Project	<b>IEEE 802.16 Broadband Wireless Access Working Group</b> < <a href="http://ieee802.org/16">http://ieee802.org/16</a> >	
Title	<b>Dynamically relay zone configuration for two-hop relay</b>	
Date Submitted	<b>2008-07-07</b>	
Source(s)	Kanchei(Ken) Loa, Yi-Hsueh Tsai, Yung-Ting Lee, Hua-Chiang Yin, Youn-Tai Lee  Institute for Information Industry (III)  Shiann-Tsong Sheu  National Central University (NCU)  Yang-Han Lee, Yih-Guang Jan  Tamkang University (TKU)	Voice: +886-2-66000100 Fax: +886-2-66061007 loa@iii.org.tw  stsheu@ce.ncu.edu.tw  yhlee@ee.tku.edu.tw
Re:	IEEE 802.16-08/028: "IEEE 802.16 Working Group Letter Ballot Recirc #28d: Announcement"	
Abstract	Dynamically relay zone configuration	
Purpose	Text proposal for 802.16j Draft Document.	
Notice	<i>This document does not represent the agreed views of the IEEE 802.16 Working Group or any of its subgroups. It represents only the views of the participants listed in the "Source(s)" field above. It is offered as a basis for discussion. It is not binding on the contributor(s), who reserve(s) the right to add, amend or withdraw material contained herein.</i>

## Dynamically relay zone configuration for two-hop relay

Figure 1 Relay zone configured by RCD

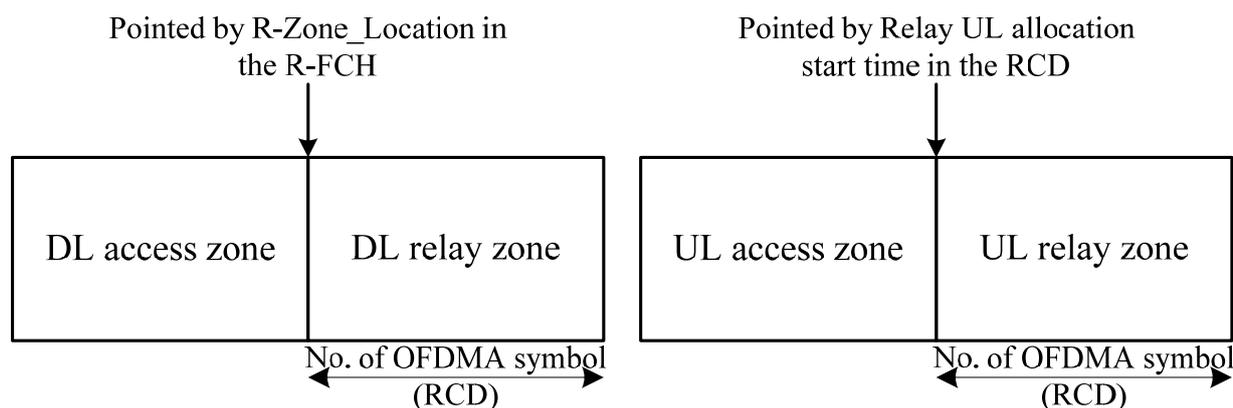
In current 16j/D5 standard, for the MR system using non-transparent RSs, the start point of the first DL relay zone is described by the R-Zone\_Location in the previous R-FCH, thus the MR-BS can dynamically configure the downlink relay zone for 2-hop relay. However, the uplink relay zone can only be configured by the RCD message, which incurs high overhead when the configuration of uplink relay zone is changed frequently. (see Figure 1)

In order to support efficient dynamically relay zone configuration for the 2-hop non-transparent RS operated in distributed scheduling, we propose adding a new R-link specific IE, namely UL relay zone configuration IE, containing the four parameters to describe the UL relay zone for R-MAP.
